# STERLING RANCH FILING 5

TRACT B, BRANDING IRON AT STERLING RANCH FILING NO. 2 RECORDED UNDER RECEPTION NO. 220714654 IN THE RECORDS OF THE EL PASO COUNTY CLERK AND RECORDER  
PUD/PRELIMINARY/DEVELOPMENT PLAN

## STERLING RANCH FILING 5 PUD Preliminary Plan

# V1\_PUDSP comments.pdf Markup Summary

### PUD PRELIMINARY PLAN

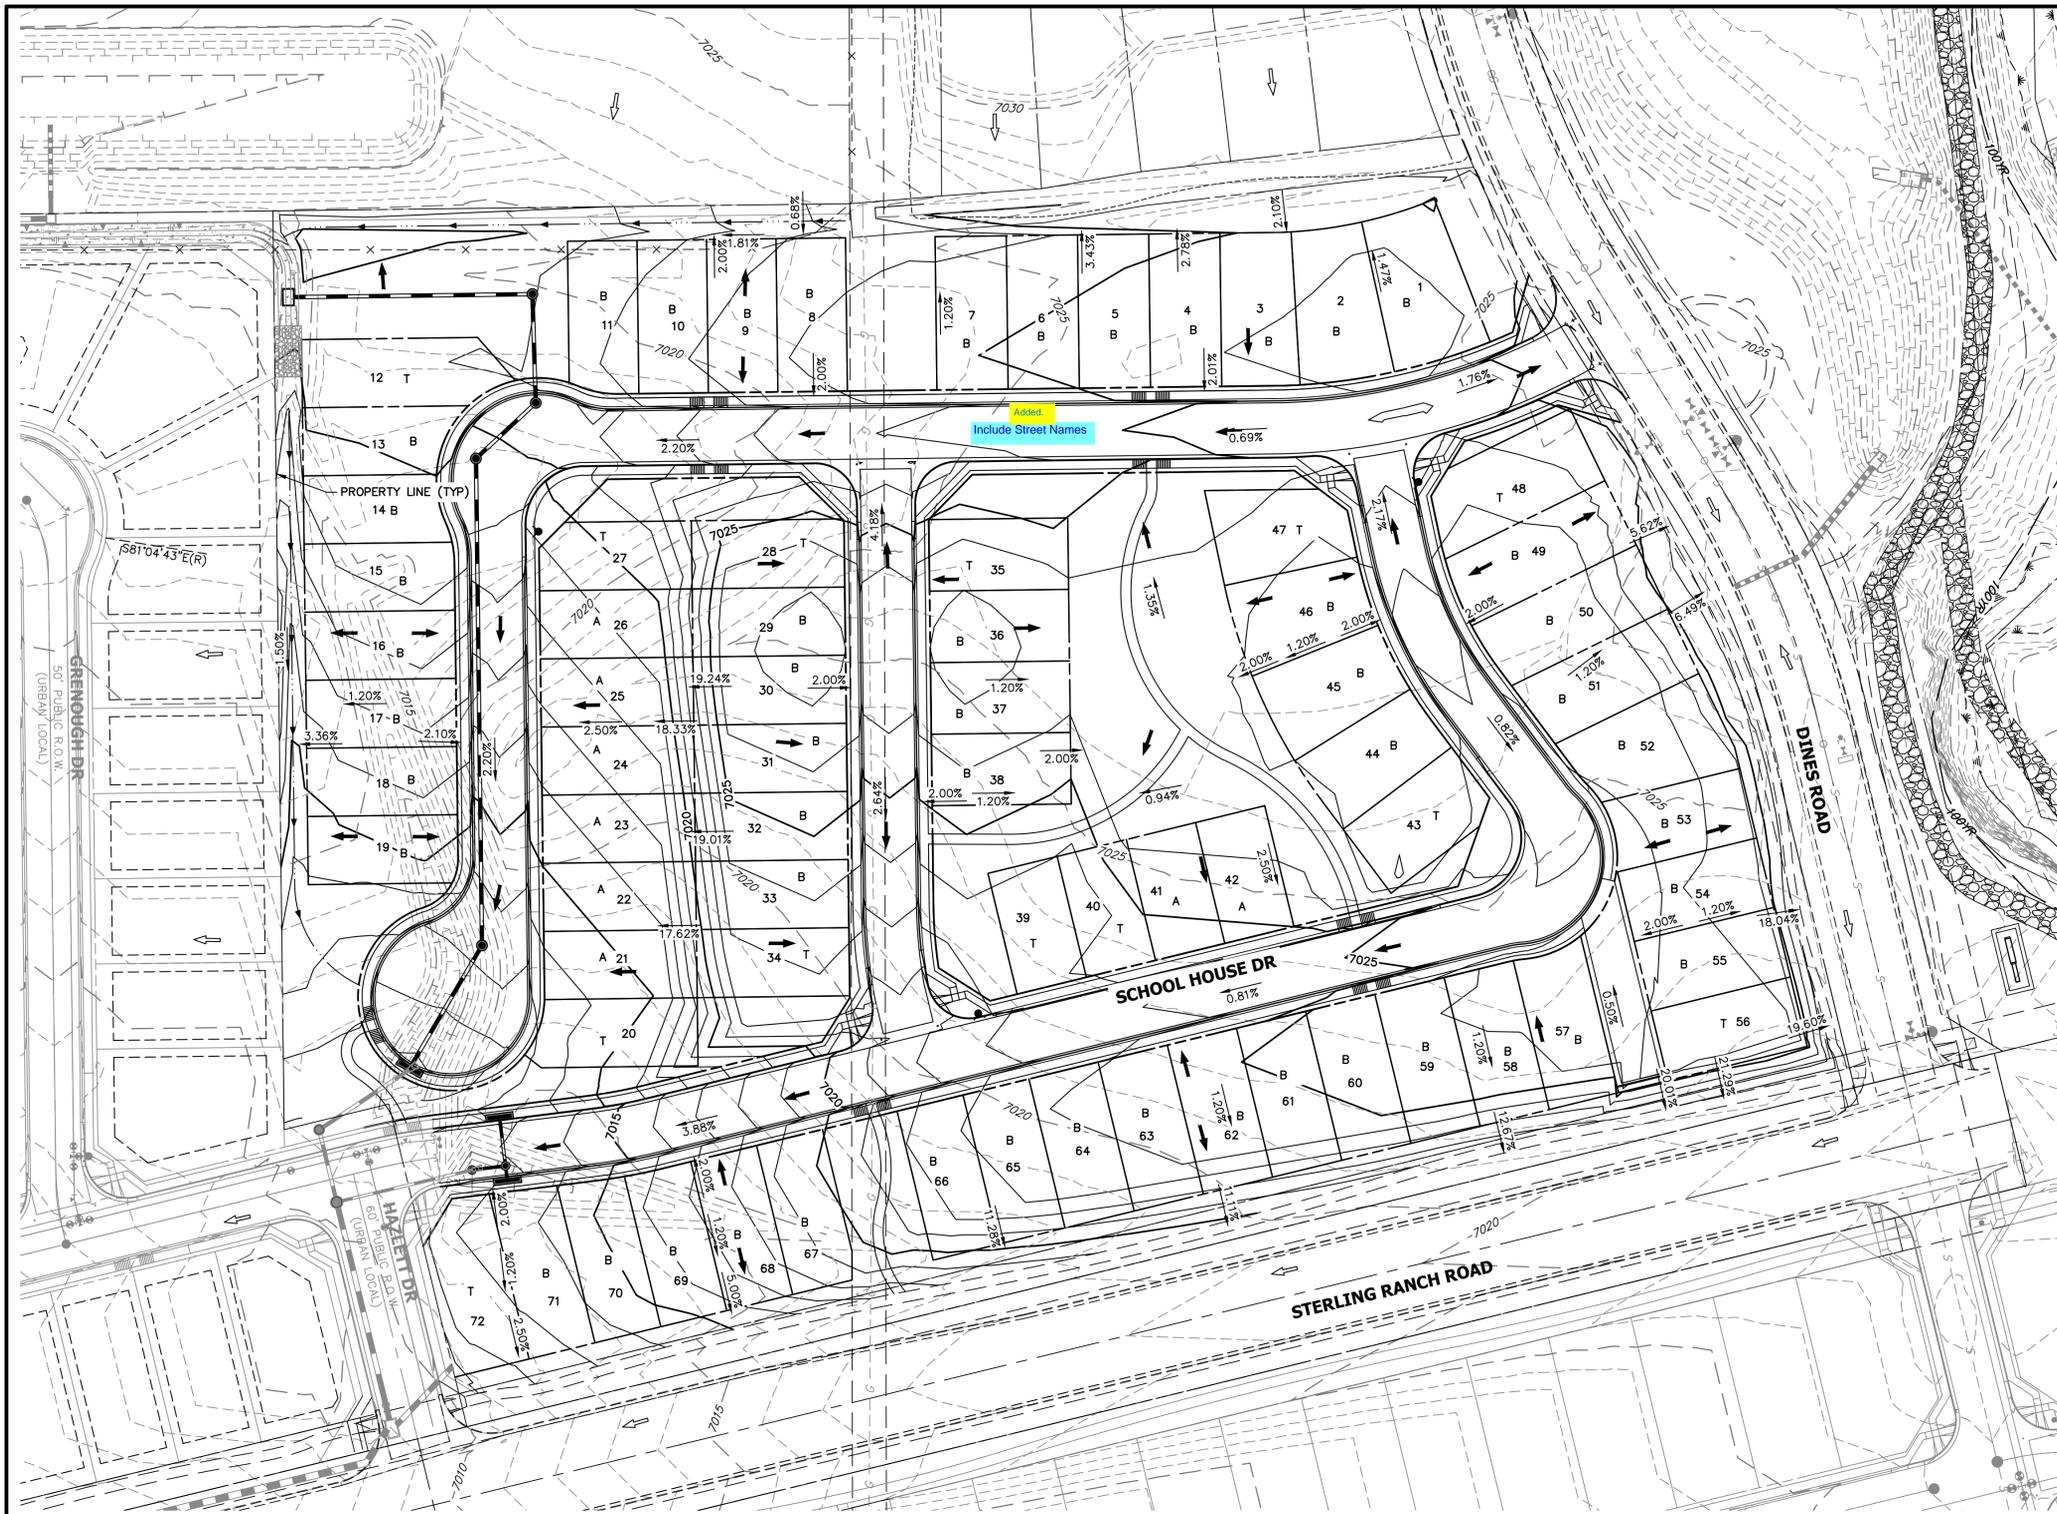
per checklist please verify distance is provided on all lots and tracts.

centerline data required

should you put a concrete wall to detract from the trash transfer station adjacent? AL2310; Possible, Noise, odor, visual impacts.

you need the industrial notice for these lots.

i dont believe a waiver of frontage is needed for these corner lots they do have more than 30 feet of frontage

Show sight distance for this intersection due to the wall

Move ramp to line with trail and other ramp

End of driveway is very close to wall. Consider shortening driveway to provide buffer between driveway and wall.

Does the wall meet sight distance?

what about a flag lot w / access easement?

please clarify in notes specifically which lots can use tract F so there are not code enforcement cases with other lot owners using Tract F

Tract data has not been finalized at this stage of the process. Tract distances and dimensions will be provided once site layout is finalized.

Centerline data has been provided. Call outs have arrow and text pointing to centerline.

Where the Property is Adjacent to an Industrial Area: NOTICE: This property may be adversely impacted by noise, dust, fumes, and light pollution caused by adjacent industrial properties and activities. The buyer should research and be aware of this potentiality and the ramifications thereof. (Use when residential is adjacent to industrial)

Note added to the cover sheet.

Lot minimum width adjusted on cover page site data tables

Sight line 350 ft added

Ramps aligned with each other. Alignment with trail is not conducive because of curb orientation.

Wall has been removed for residential.

Yes

Easement added to create a shared driveway - ownership and maintenance responsibilities have been noted.

Easement added to create a shared driveway - ownership and maintenance responsibilities have been noted.

STERLING RANCH FILING 5  
 UTILITY PLAN  
 SHEET 5 OF 9  
 JOB NO. 25188.16

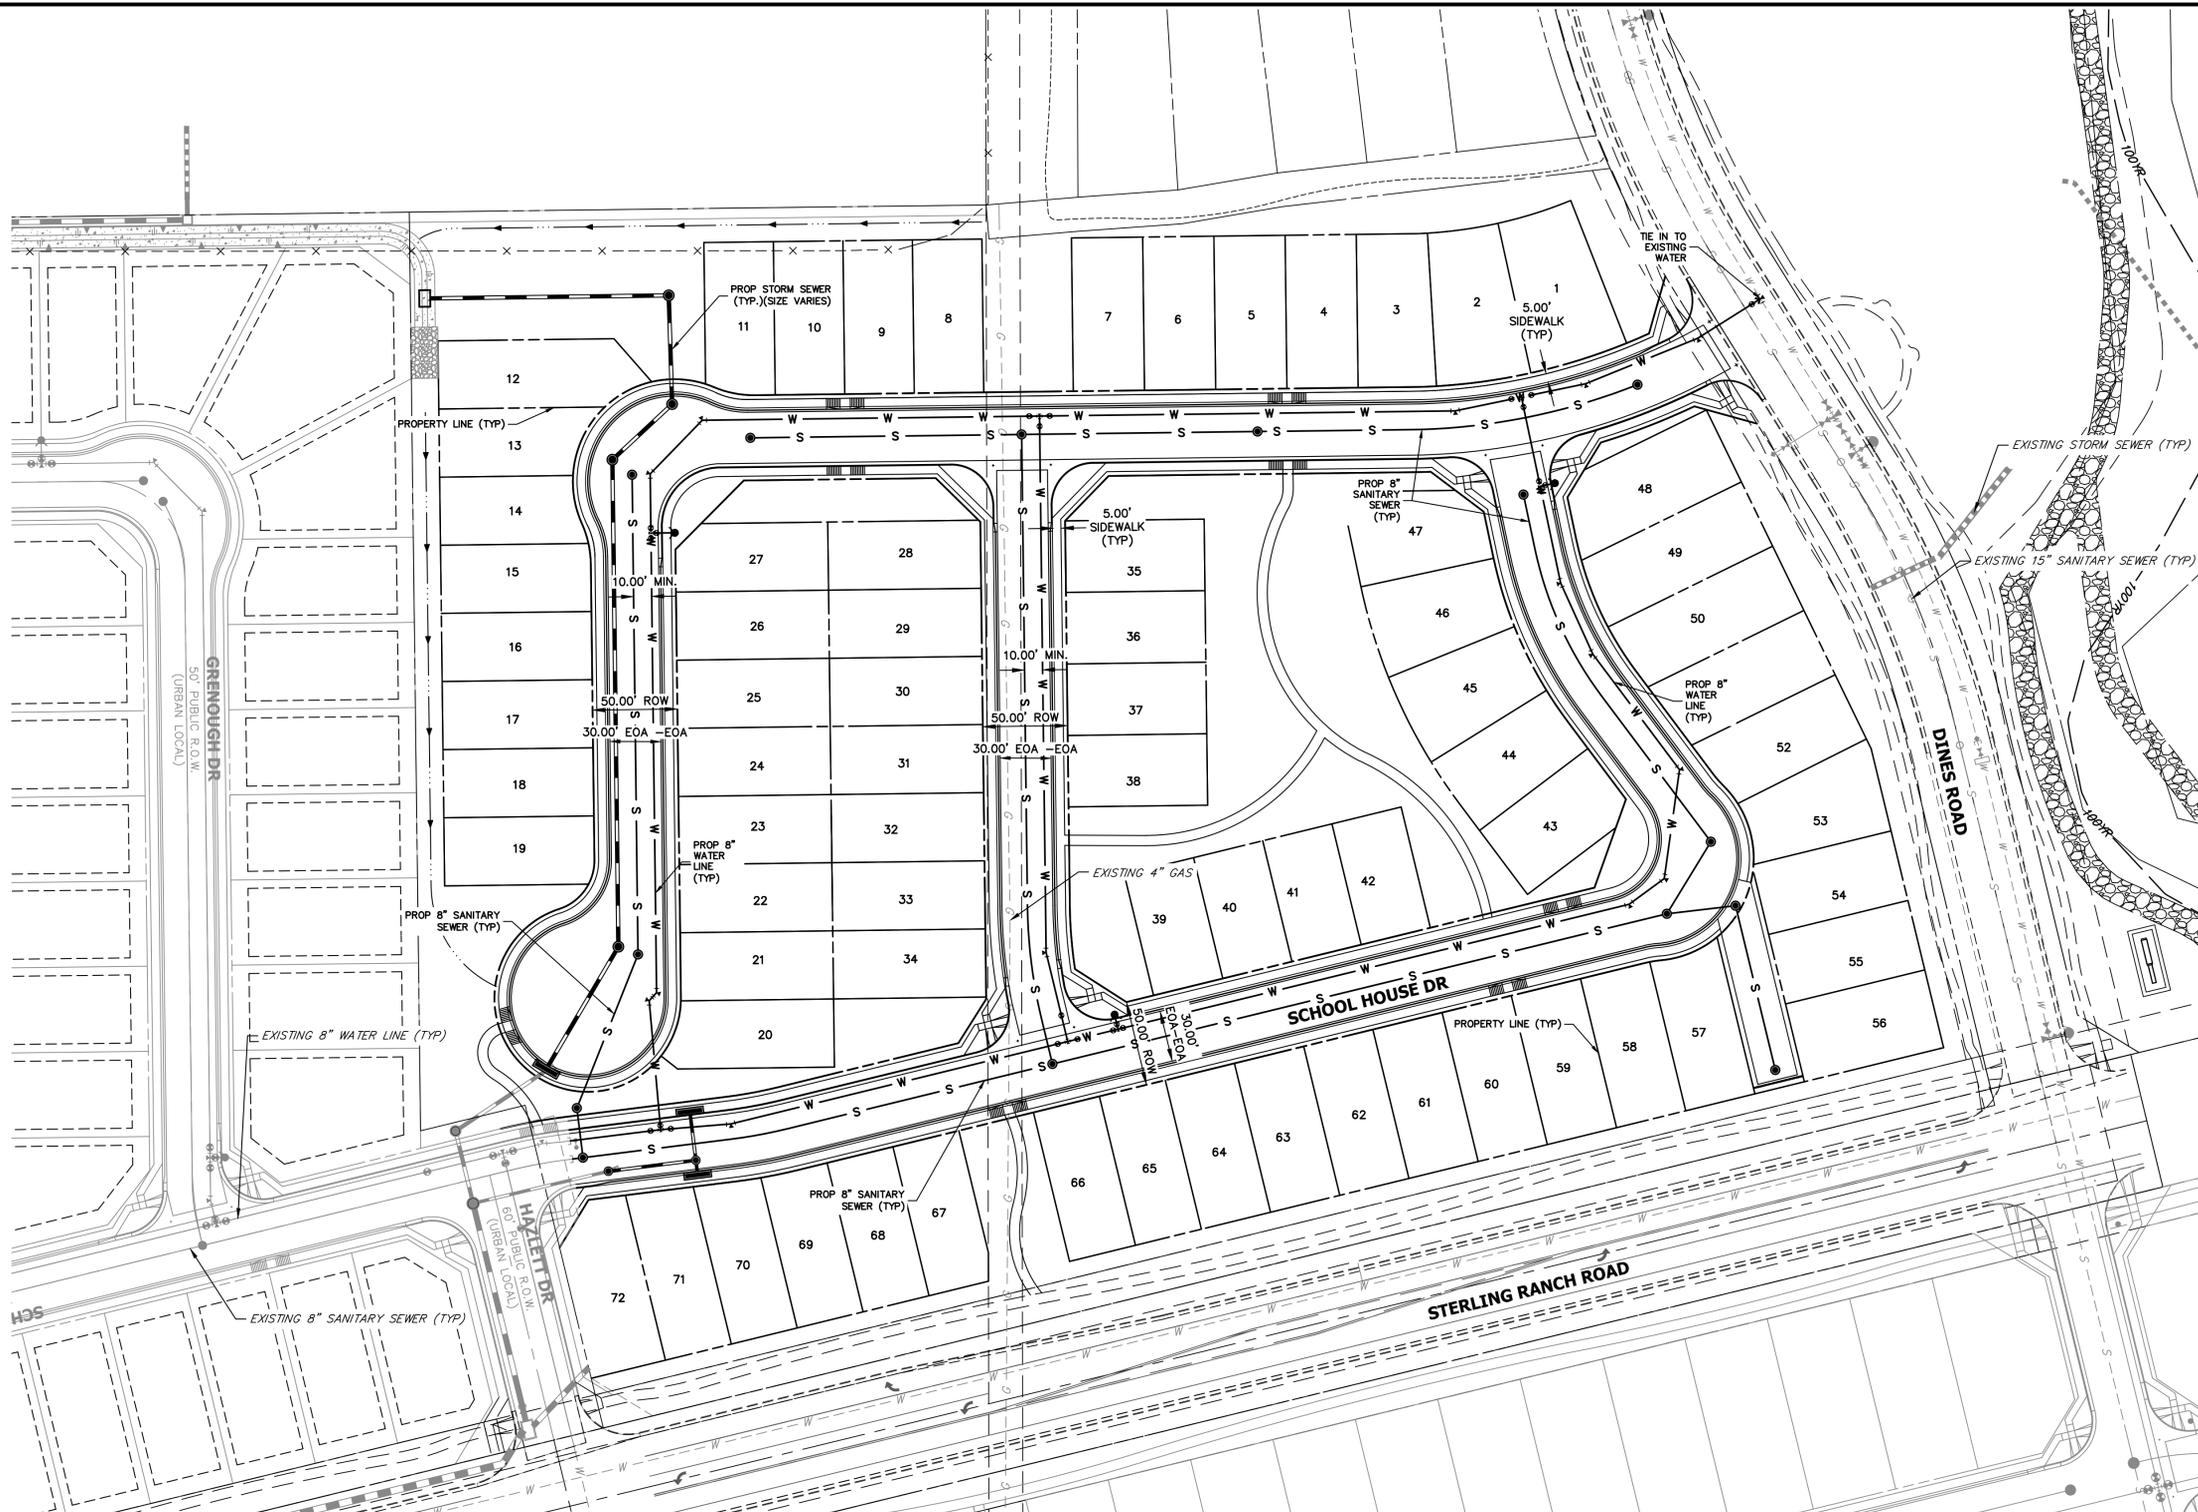
Label all easements  
 Include service lines

### PUD PRELIMINARY PLAN GEOHAZARDS CONSTRAINTS MAP

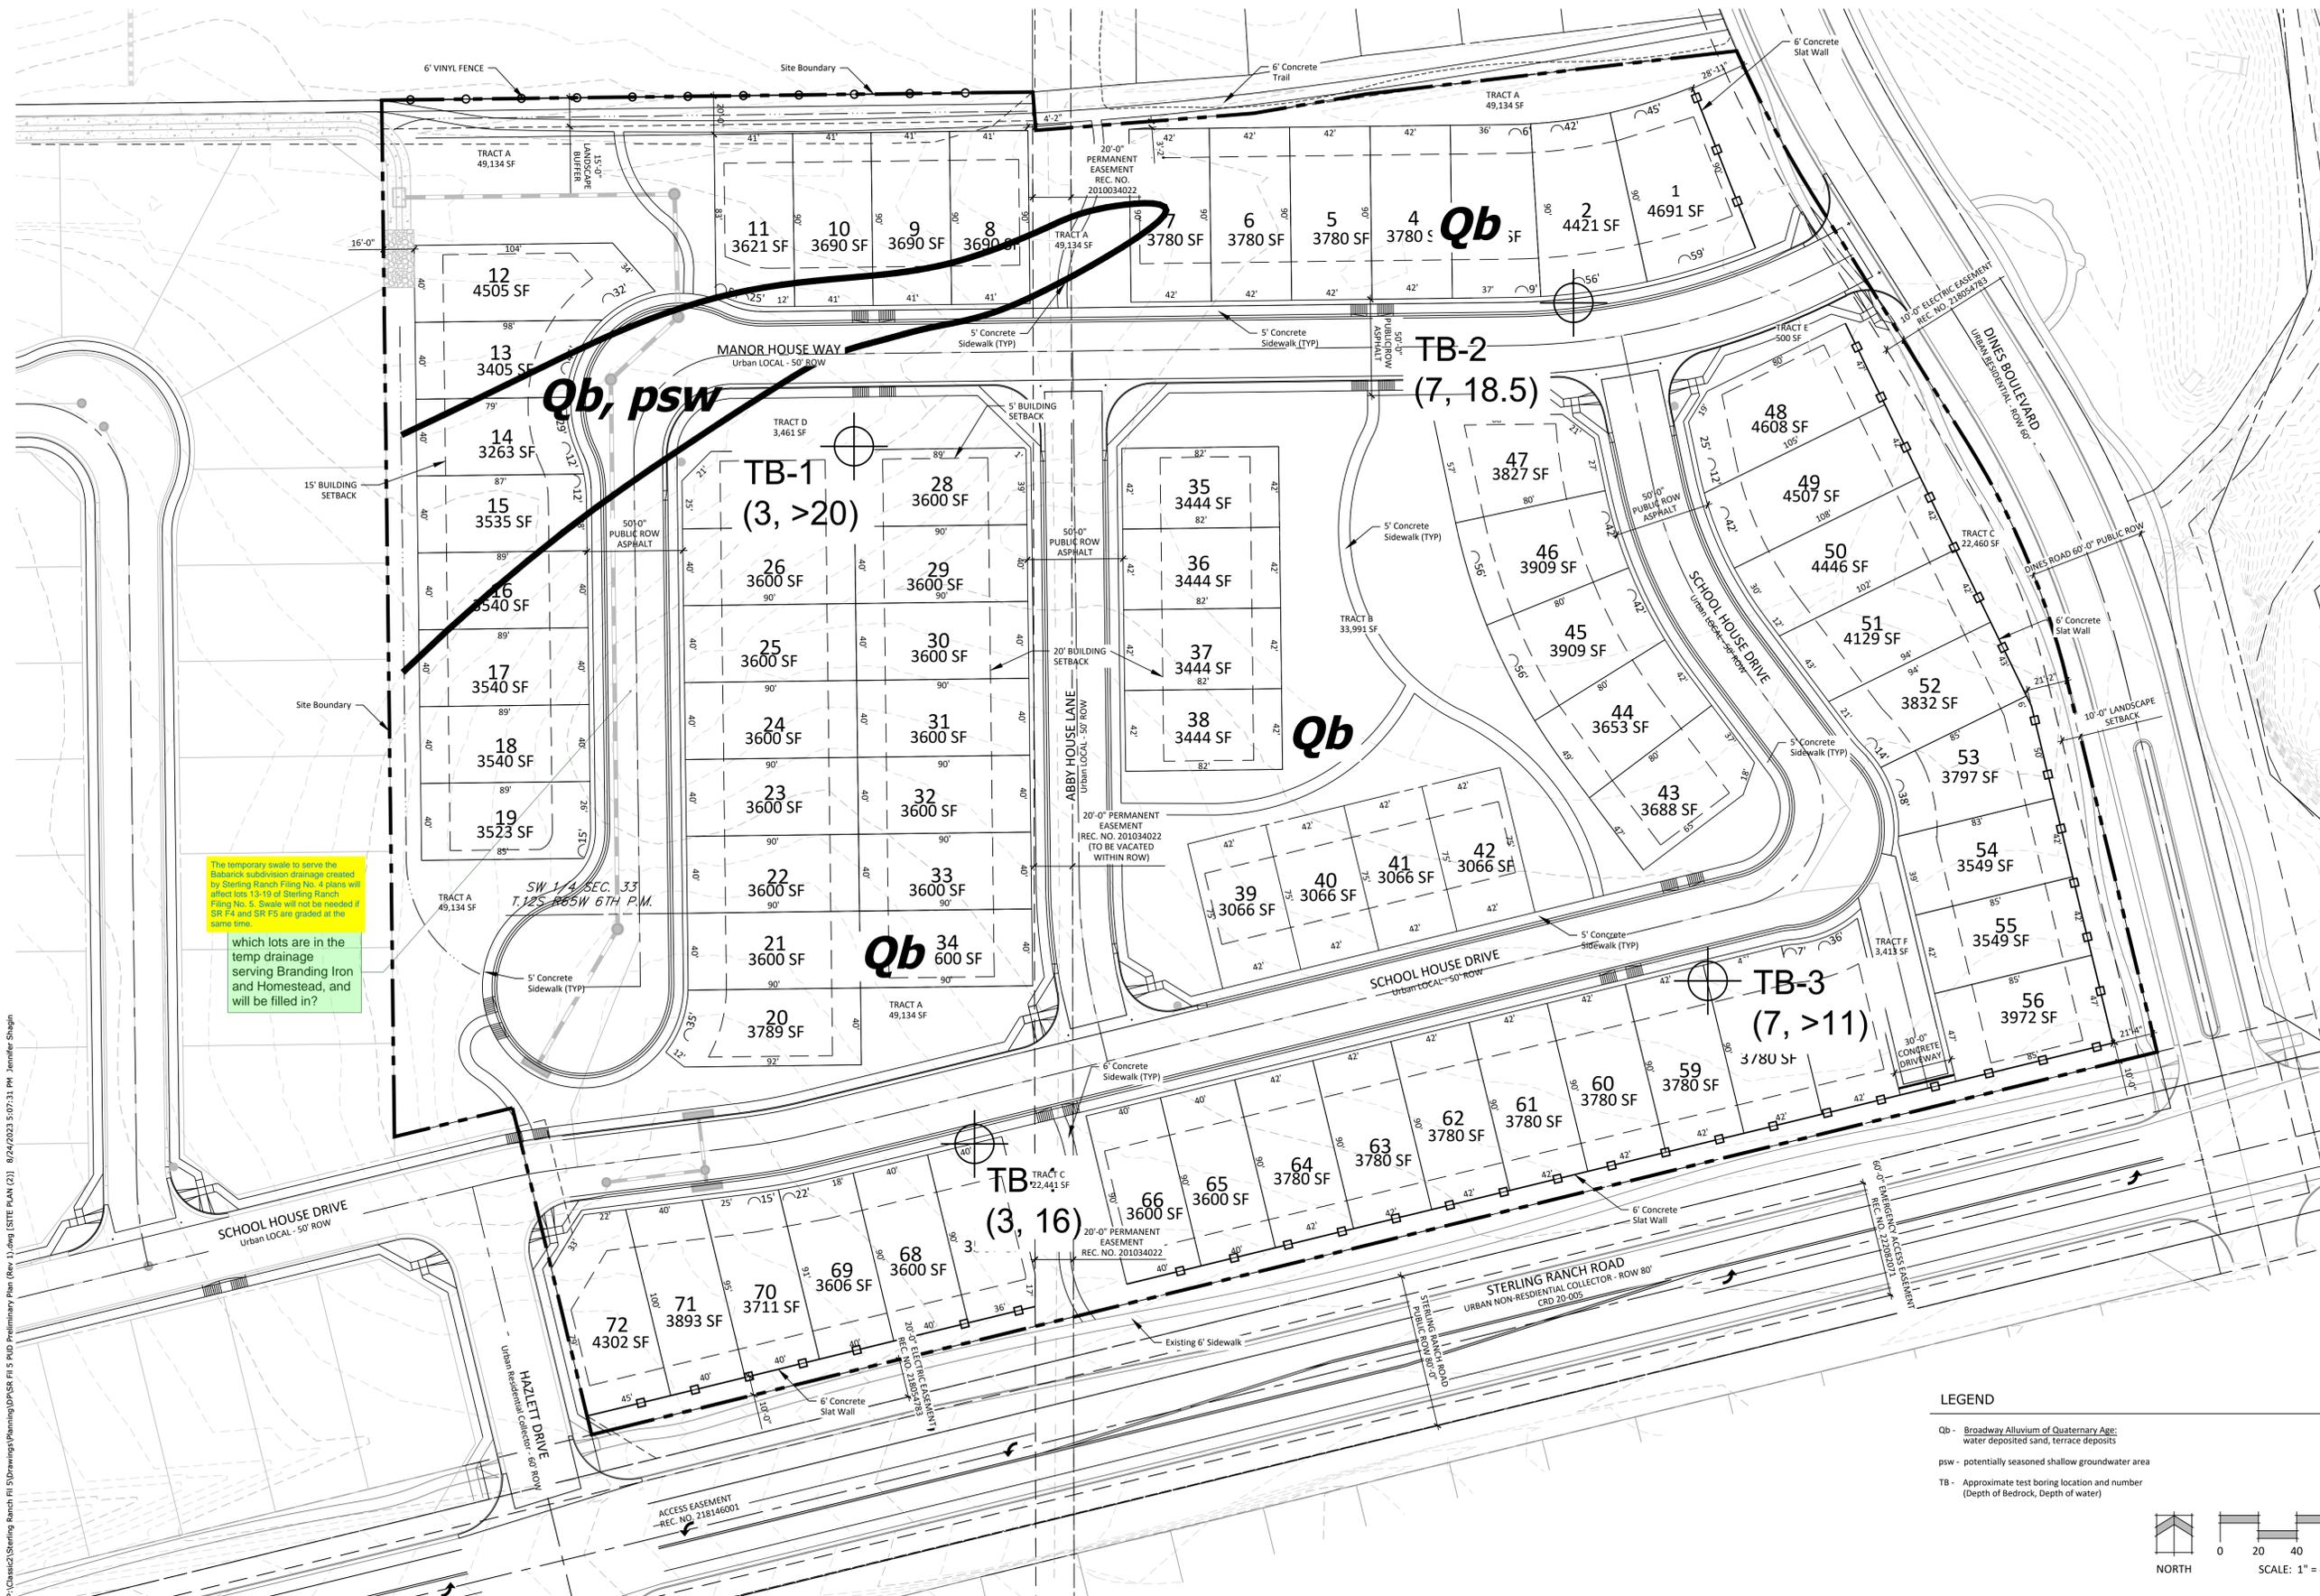
which lots are in the temp drainage serving Branding Iron and Homestead, and will be filled in?

The temporary swale to serve the historic subdivision drainage created by Sterling Ranch Filing No. 4 plans will affect lots 13-19 of Sterling Ranch Filing No. 5. Swales will not be needed if lots 14 and 15 are graded at the same time.
